# CLIO II

## 12 VEHICLE WILL NOT START

**Title:** Fit an earthing clip.

Fig. 1

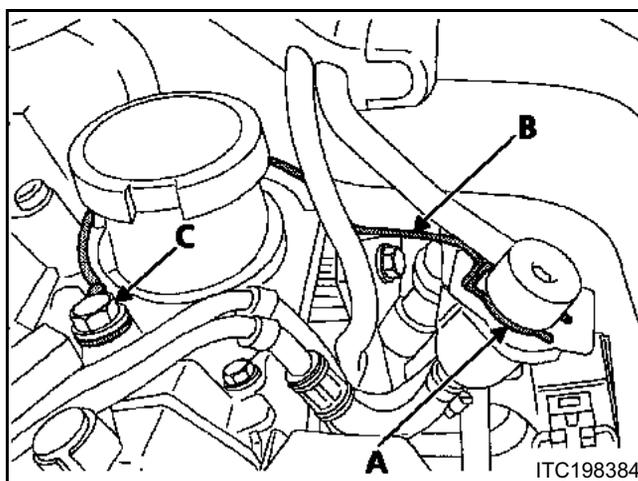
- Check the presence of the wiring (B) (Fig. 1).
  - If the wiring is not present:
    - Disconnect the battery.
    - Apply pressure to the fuel regulator.

- Remove the retaining clip (A) (Fig. 1) from the fuel pressure regulator using a small screwdriver.
    - IMPORTANT: do not damage the plastic edge of the injector gallery.**

- Fit the new clip **Part No.: 77 00 111 986**
    - Run the wiring (B) (Fig. 1) between the wire for plug n° 4 and the injector gallery, then around the oil filler well.

- Remove the radio anti-interference condenser mounting bolt (C) (Fig. 1).
    - Insert the terminal for the wiring (B) (Fig. 1) between the condenser and the cylinder head cover.

- Refit bolt (C) (Fig. 1).
    - Reconnect the battery.
    - Set the clock and enter the radio code.
  - If the wiring is present:
    - Test the electrical continuity.
